## CALIFORNIA COASTAL COMMISSION

## STAFF REPORT: REGULAR CALENDAR

**APPLICATION NO.:** 4-98-054

**PROJECT LOCATION:** 19537 Cave Way, Topanga, Los Angeles County

# Stability of Slide Section A-A'

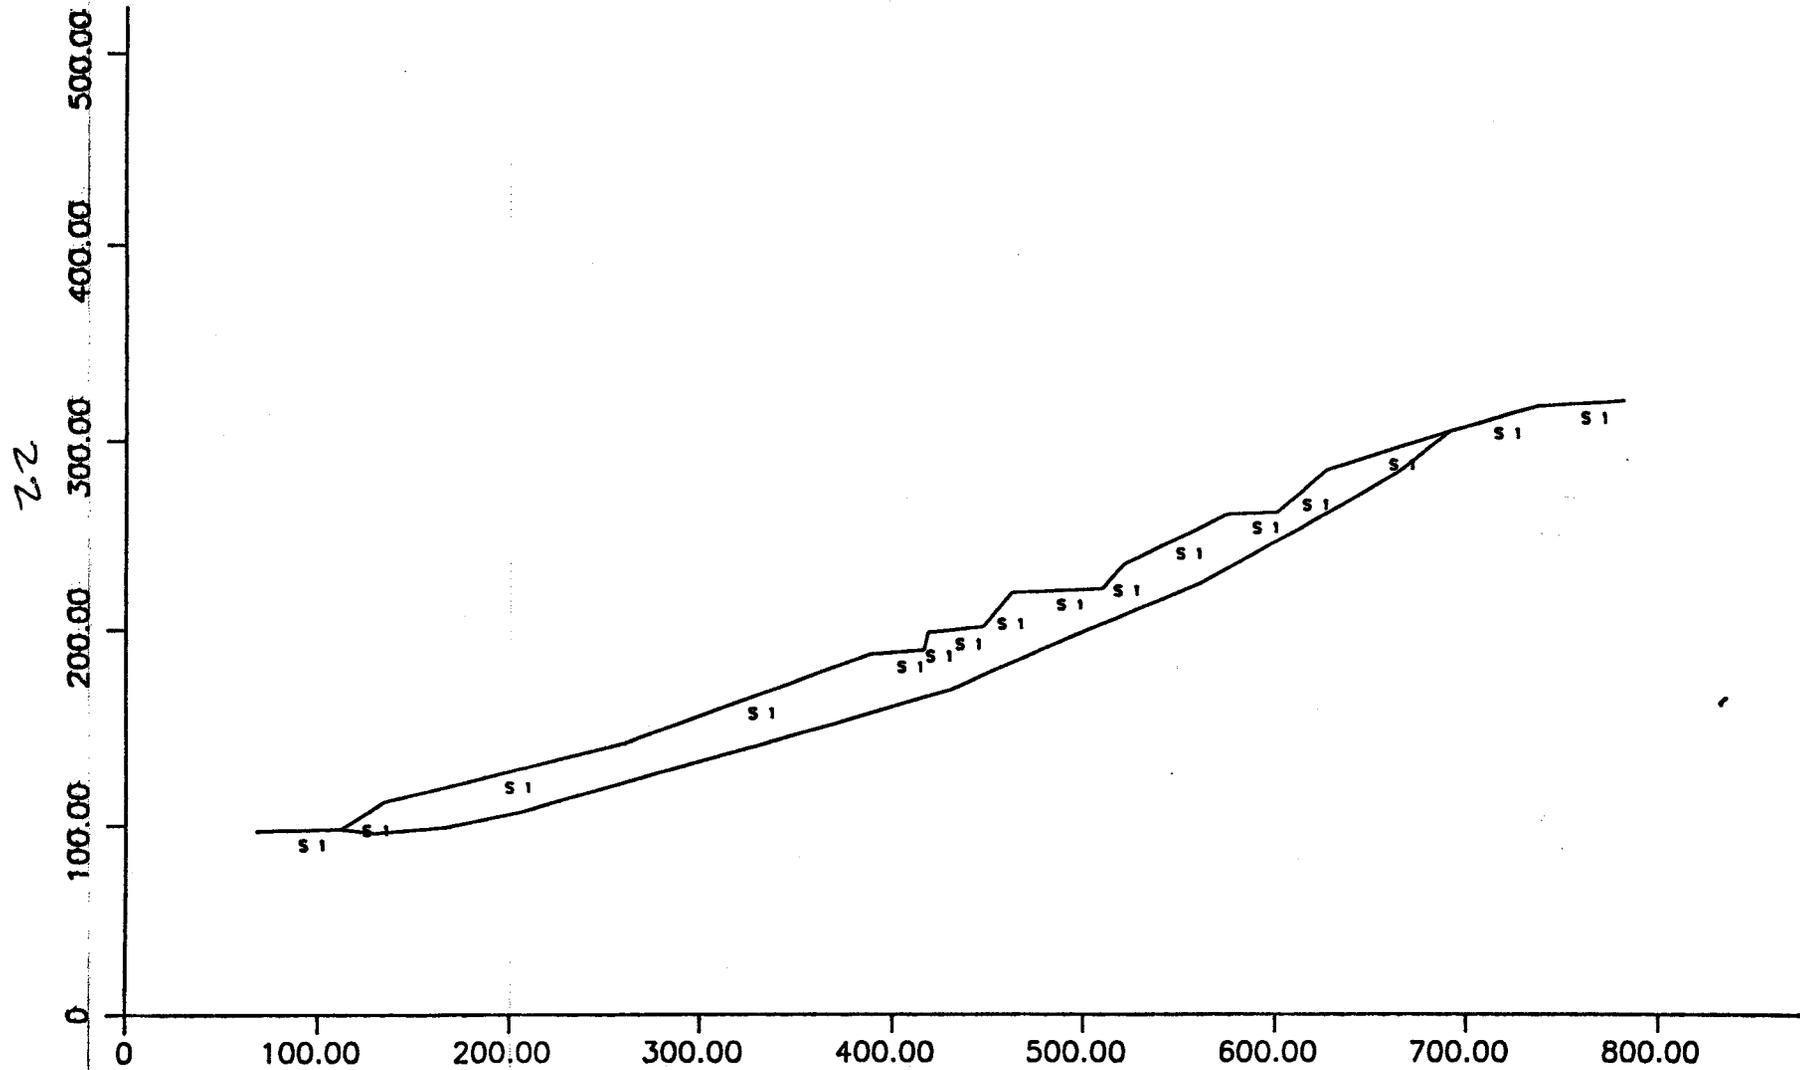
Regarding the slope stability analysis, the staff geologist, concludes that the calculated factor of safety (FS) of 1.834, is far in excess of the industry standard of practice of 1.5. However, it appears that the shear strength parameters used in this analysis were collected from a sample of landslide debris collected at a depth of 5 feet in boring DH-01, far above the slide plane of the ancient landslide. Further discussions with Mr. Jon Mahn, project engineer for the applicant, indicate that this is in error; the shear strength parameters used in the analysis do not match the test results presented in the report. Accordingly, the relatively high shear strength values used in performing the analysis are not supported. The ultimate shear strength obtained from the sample taken at five feet is quite high, and the value used in the analysis also is quite high. It would be anticipated that the shear strength of material along the slide plane would be considerably lower. Further, as this is an existing slide plane, an ultimate shear strength is not the appropriate value, rather residual shear strength should be used. Finally, consideration should be given to using remolded samples of the slide gouge encountered at 26 feet to most accurately predict shear strengths. Justification should be provided as to the suitability of a drained test such as the direct shear test. For these reasons, staff cannot be confident that the FS of 1.8 obtained from the slope stability analysis accurately portrays the actual factor of safety against sliding along the existing slide plane.

The Coastal Commission, unlike the County of Los Angeles, generally requires that a seismic analysis of slope stability also be performed for habitable structures. A pseudostatic slope stability analysis is the most common (although not necessarily the best) means of assessing slope stability under seismic conditions. Generally, a factor of safety against sliding of greater than 1.1 using a seismic coefficient of 0.15g and undrained shear strength data is sufficient to assure stability under seismic loading. No such analysis has been submitted.
